**Hydro One Networks Inc.**

**EB-2007-0050 – Hydro One Networks' Section 92 Bruce - Milton Transmission Reinforcement Application – Hydro One Networks' Response to Interrogatory Questions from OEB Staff**

**Ontario Energy Board (Board Staff) INTERROGATORY #1.1 List 1**

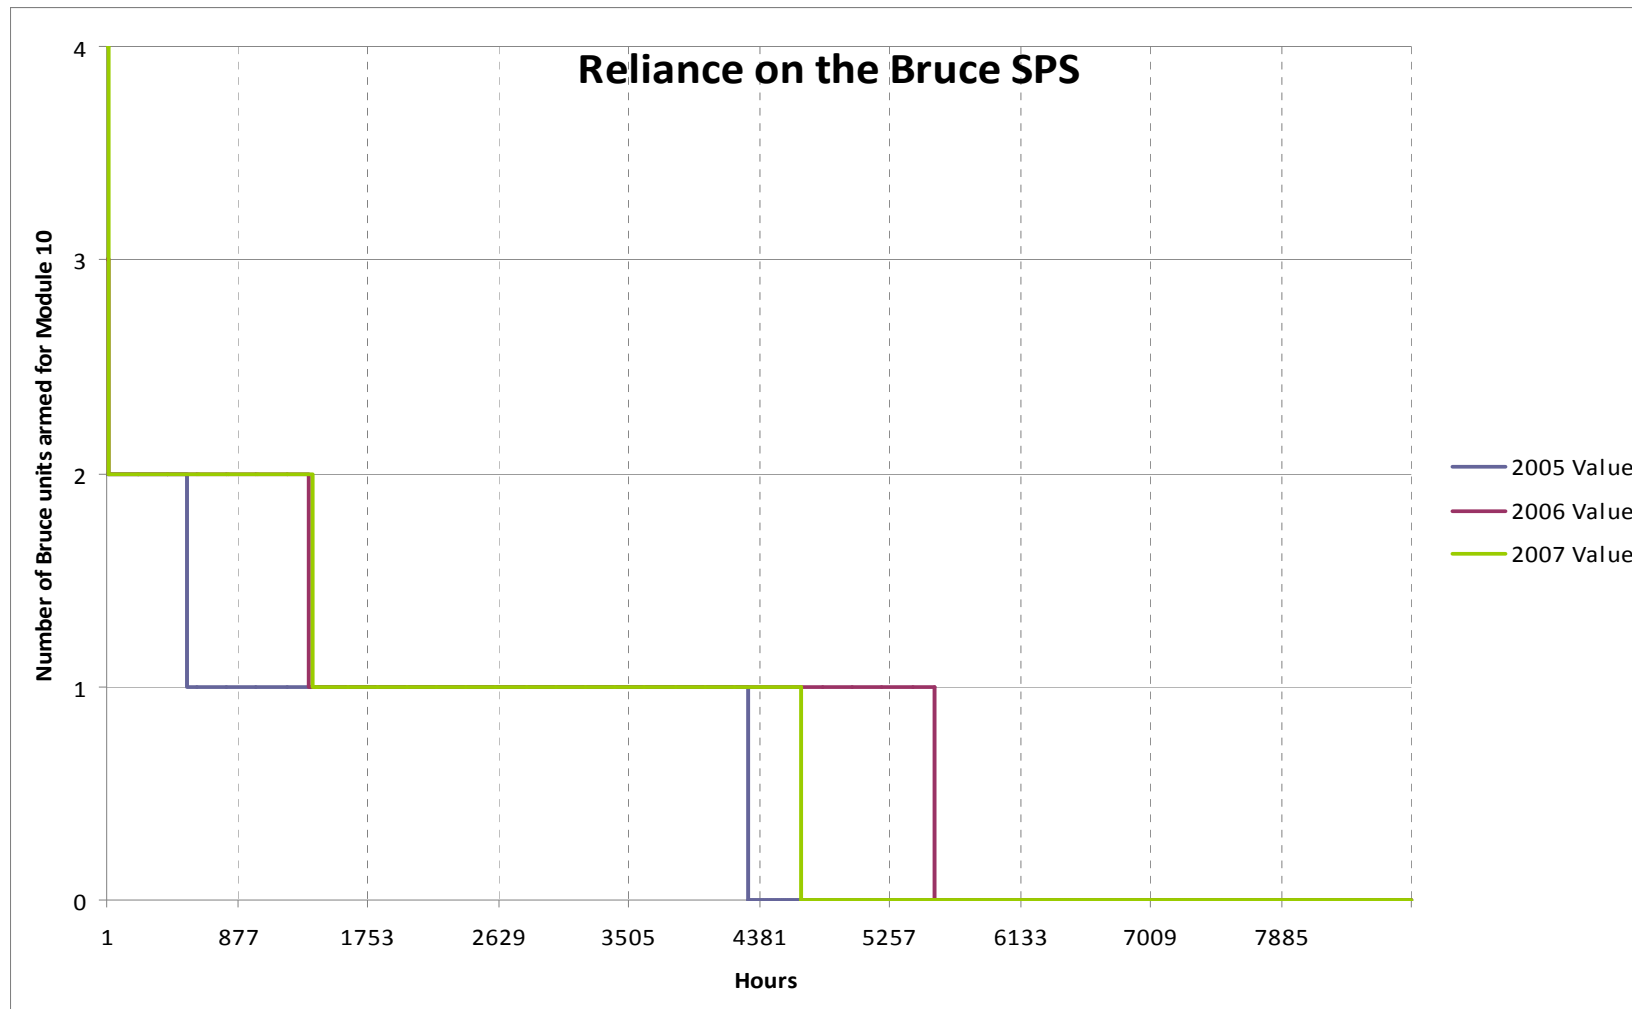
- (v) Please provide a full description of the Generation Rejection Scheme that was utilized during the period when all 8 units at the Bruce complex were operational delivering about 6,500 MW to the electricity system.

(v) The Bruce Special Projection System (BSPS) is a collection of special protection systems installed at Bruce GS and associated stations that perform pre-defined control actions (such as: generation rejection, reactor tripping and load rejection) in response to recognized contingencies in the Bruce area. By providing these capabilities, restrictions on the maximum output of Bruce GS and other system parameters can be reduced or eliminated, while still respecting the established system criteria for voltage stability and equipment thermal loading. The BSPS was installed in 1991 and has had three modifications since it was placed in-service.

The BSPS monitors breaker and switch status in the transmission system in the Bruce area to determine how the transmission circuits are connected together. When it determines that a critical transmission contingency has occurred by monitoring breaker status, it initiates a pre-planned control action.

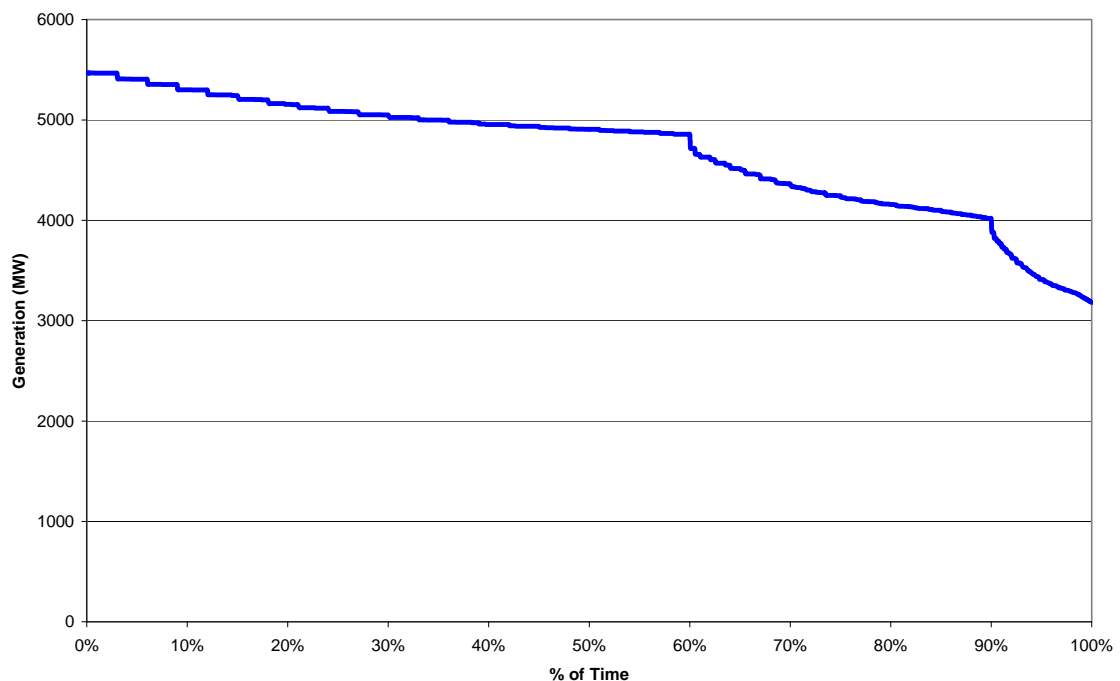
(iii) Please produce two “Power Flow Duration Curves or (PFDC)”, one for Winter (5 months, Nov to March) and one for Summer (7 months, April to October), reflecting

- the total generation in the Bruce Complex [Bruce A Units (1 and 2) back in service in 2009, with units 3 and 4 taken out one at a time till 2011]
- the committed wind generation of 725 MW as well as the potential wind generation of 1000 MW, both assuming Capacity Factors of 20% in Summer and 40% in Winter.

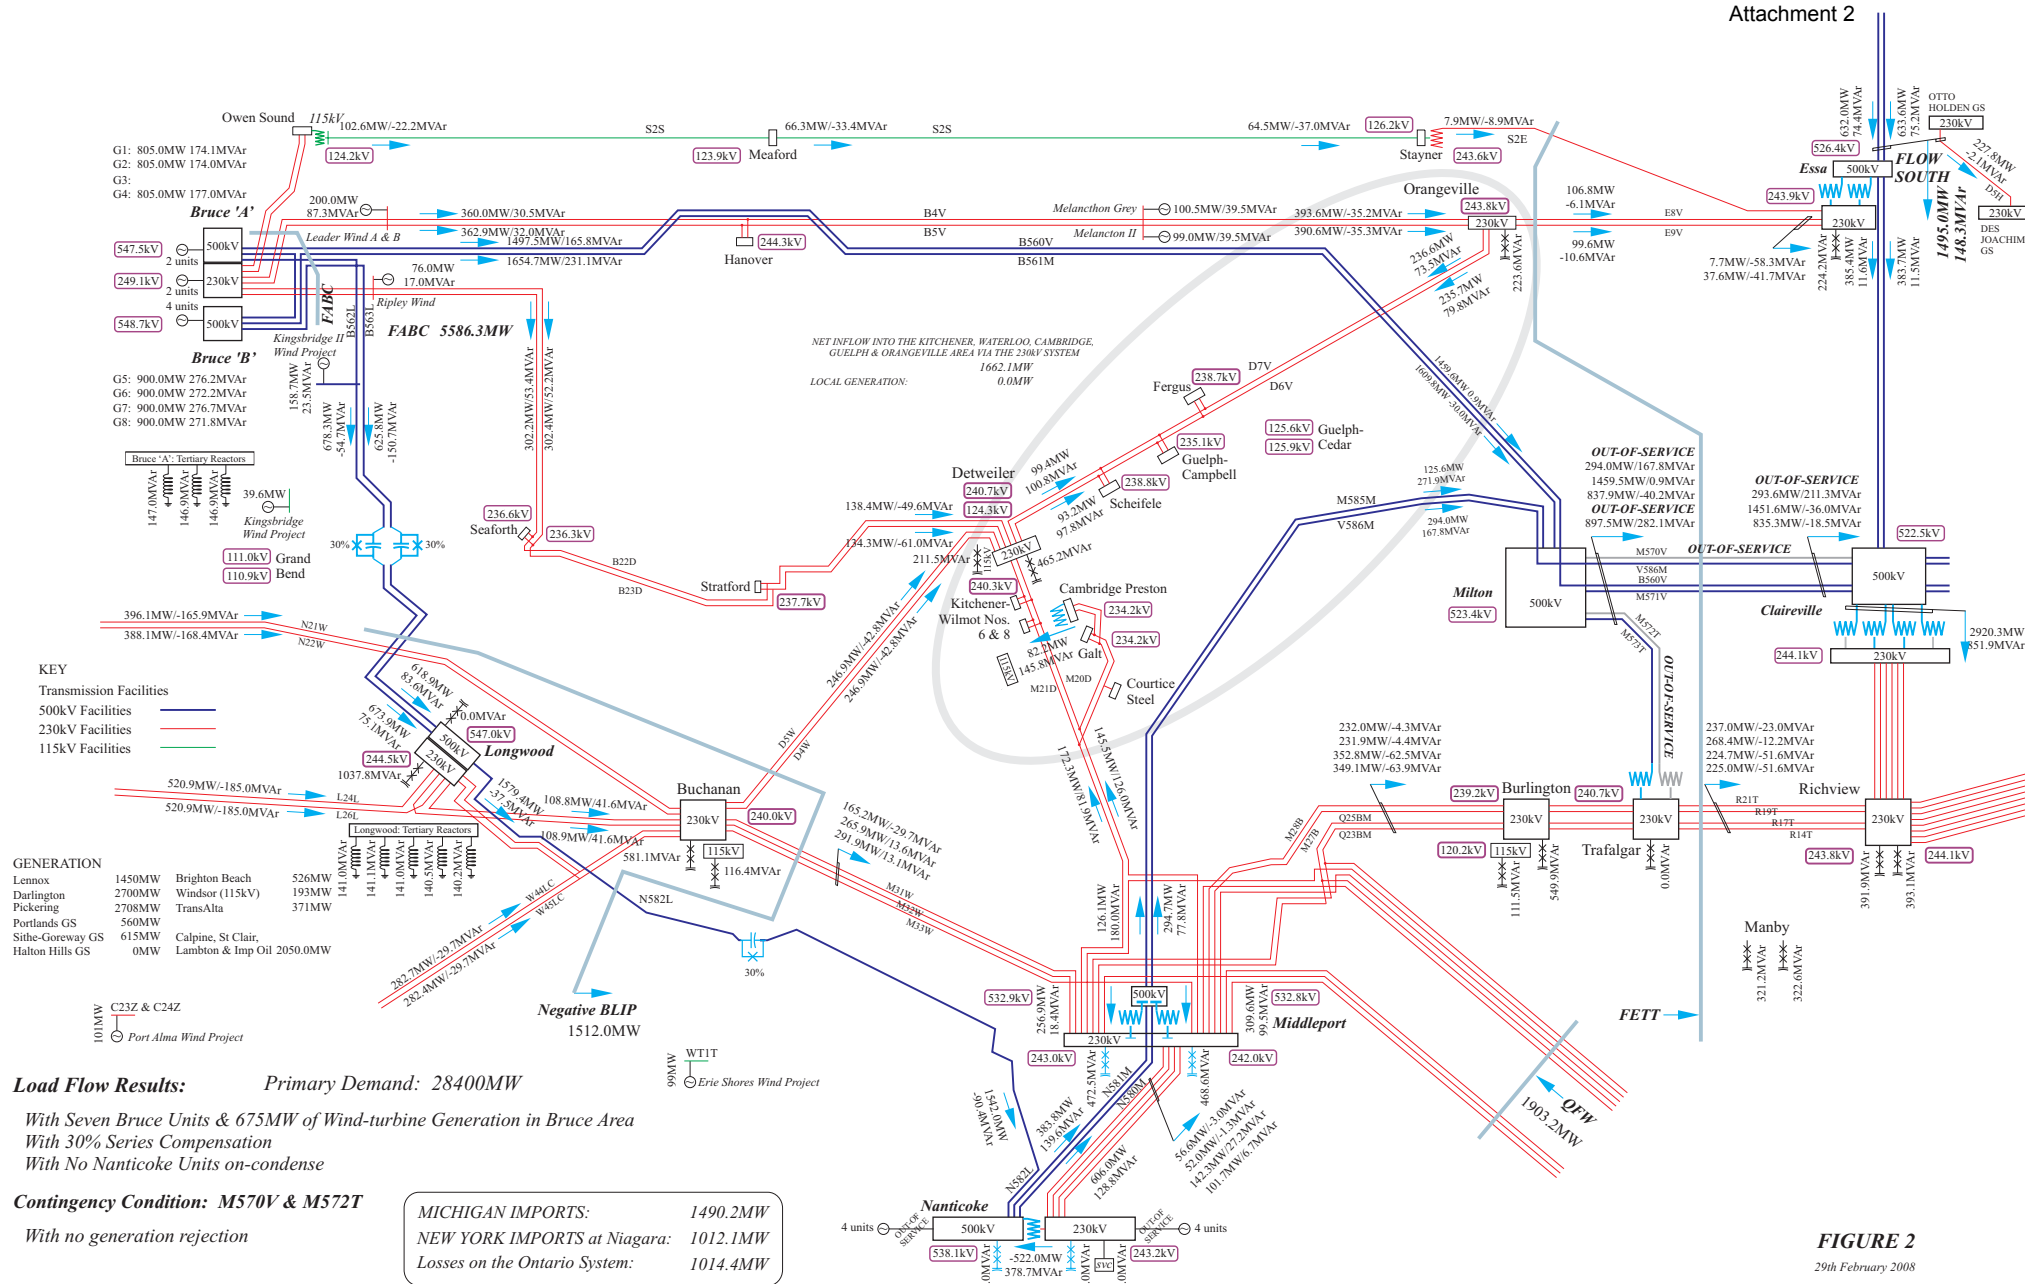
It is essential and informative to have the IESO perform additional analysis to show the effect of the scenario where the Series Compensation is assumed in-service by 2009, on the system prior to and after the installation of the proposed new transmission lines.

With the assumption that the Series Compensation installation is in service by 2009 with sizes and location per the IESO suggestion i.e., 30 % compensation level [see Ref. (b)], please carryout a repeat of five system simulations that will show the load flows under normal and contingency conditions as described in the above Ref.(a), and whose results were depicted in Diagrams 4, 5, 6, 7 and 13 of that Ref.(a).

Under the Bruce to Milton option, the 500 kV bus-bar at Milton SS must be reconfigured. Under the series compensation scenario, the Milton 500 kV bus-bar would not require reconfiguration. Consequently, three of the five contingency conditions that were examined in the Bruce to Milton SIA Report and referenced above—involving the new 500 kV circuits and specifically the reconfiguration of the 500 kV bus-bar—would not be applicable.

The IESO has therefore examined the two remaining applicable contingences that do not involve reconfiguration of the Milton SS 500 kV bus-bar for breaker failure conditions involving the following circuits:
